T.I. no.: 2015-03 Updated: -	Topic: Steam nozzles
---	-----------------------------

Date: 22/01/2015
Affected machines: SCP
From serial number: 1510...
From date: Calendar week 10

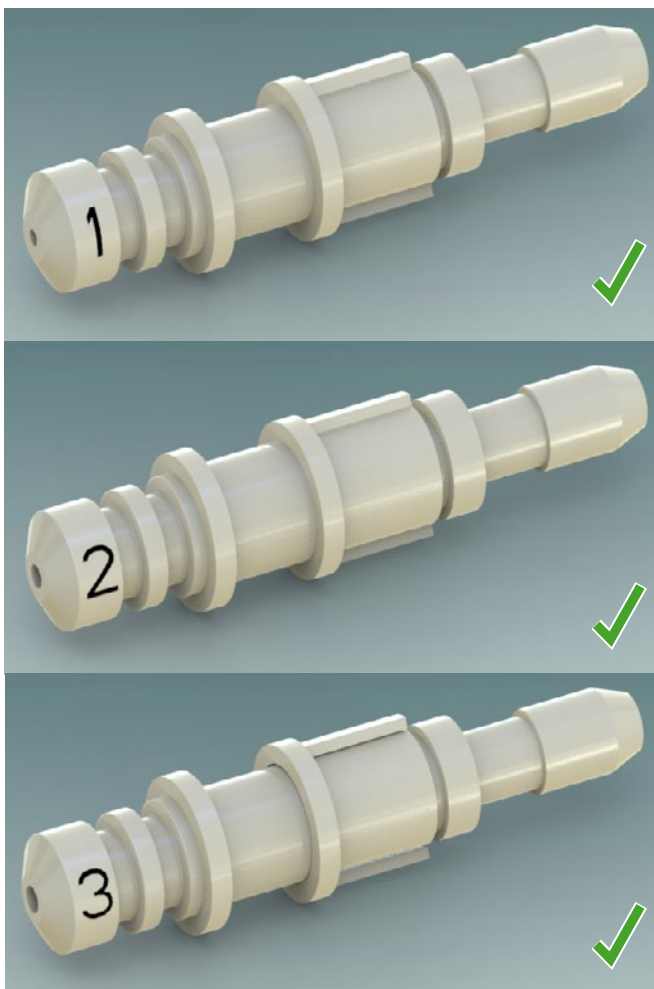
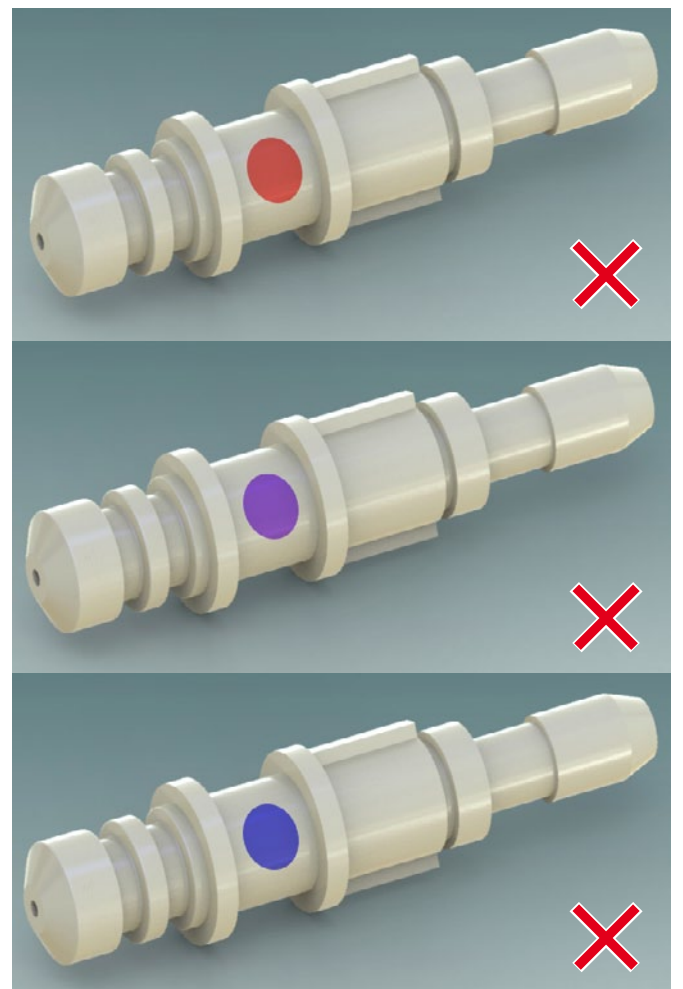
To allow unambiguous identification of the steam nozzles, numerical designations will now be used in place of colour markings. The numbers will be engraved on the steam nozzles.

The article numbers of the steam nozzles have not changed. Starting in calendar week 10, only steam nozzles with engravings will be installed at the factory.

For SCP machines with the Powerpack option (2 kW and 3 kW models), we generally recommend switching over to the new engraved steam nozzles in order to prevent possible variations in the quality of hot milk foam.
